গণপ্রজাতন্ত্রী বাংলাদেশ সরকার
শ্রম ও কর্মসংস্থান মন্ত্রণালয়
কলকারখানা ও প্রতিষ্ঠান পরিদর্শন অধিদপ্তর

ক্যাপ পর্যবেক্ষণের তথ্য

কারখানার নাম	মেসার্স গুড গাইস লিঃ
ঠিকানা	J-L-12, Dag # 505, 554, Bailjury, Turag, Uttara, Dhaka
কারখানার কোড	DHK234
কালার কোড	
মূল্যায়নের ধরণ: কাঠামোগত মূল্যায়ন	পর্যবেক্ষণের তারিখ: ০৩-০৪-২০২৩
১. পর্যবেক্ষণ

পরিদর্শন পর্যবেক্ষণ	Floor load plan
কাপ আইটেম ক্যাটাগরি

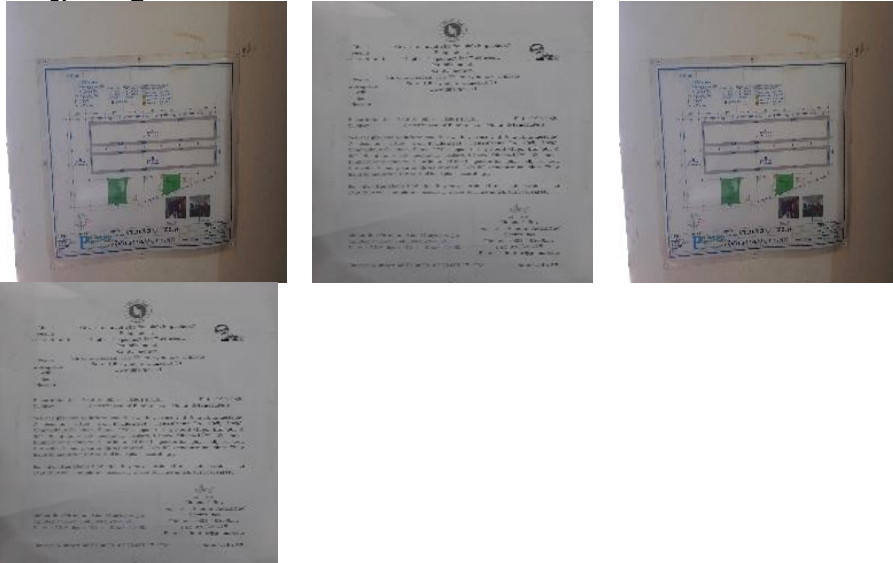
কার্যক্রম	The factory owner has to prepar and submit the load plan for all floors with in three weeks for approval and has to arrange displaying the vetted load plan of each floor on the wall in a conspicuous location.
সুপারিশের তথ্যসূত্র	
কারখানার কার্যক্রম	
অগ্রাধিকার	প্রয়োজ্য নয়
চূড়ান্ত সময়সীমা	-
সংশোধিত সময়সীমা	২৫-০৭-২০২২
অগ্রগতির অবস্থা	সংশোধিত
মন্তব্য	11/02/2020: All design & drawings are submitted to DIFE without any retrofit. DEA completion certificate also got from the consultancy firm. Load plans are also posted on walls. 13.07.2020 Visit observation: All design & drawings are submitted to DIFE without any retrofit. DEA completion certificate also got from the consultancy firm. Load plans are also posted on walls. 09.11.2020: Factory management has posted approved floor load plan in all entrance visible place. 31.08.2021: Load plan posted on walls of each floor. Loading found under 60 psf (3KN/m2) on each floor. All Structural design & drawings were approved from DIFE RCC without any retro-fication. The factory management have got Business as Usual Certificate from DIFE on 01/11/2020 for Structural. 21/08/2022: Load plan was found posted on walls of each floor during inspection date. 03/04/2023: Load plan was found posted on walls of each floor during inspection date.
